Meeting	Jul 25, 2018 - RSD Special Board Meeting
Category	6. Consent
Subject	6.21 Approval of Change Order with Taft Electric for Scope changes.
Access	Public
Type	Action (Consent)
Fiscal Impact	Yes
Dollar Amount	146,741.00
Budgeted	Yes
Budget Source	Measure G Funds
Recommended Action	It is recommended that the change order with Taft Electric be approved.

Subject: Rio STEAM K-8 Campus
Rio School District
Oxnard, CA

Re: Project 0045-015 Rio STEAM K-8 Campus
BP #20 Electrical and Elevator
Recommendation to Approve PCO #20.5 Taft Electric

Attachments:
[bidg.c site ling.pdf](#)

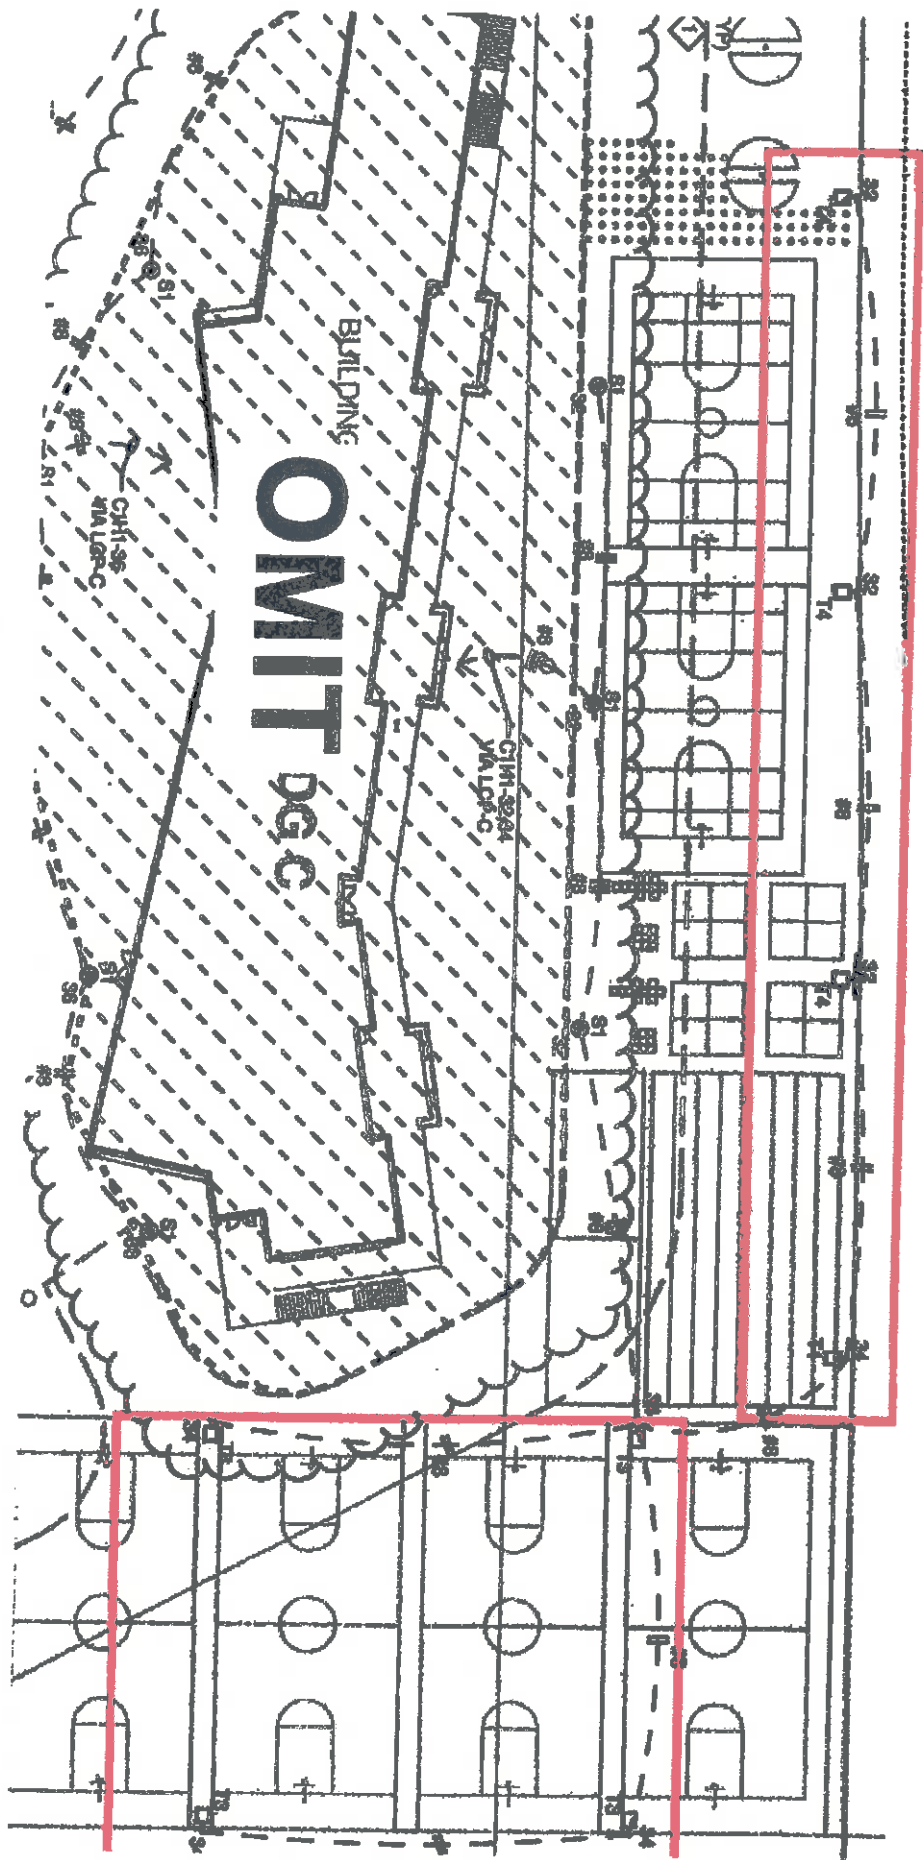
Where should the site light fixtures north of Future Building C be fed from?
See attachment for fixtures in question.
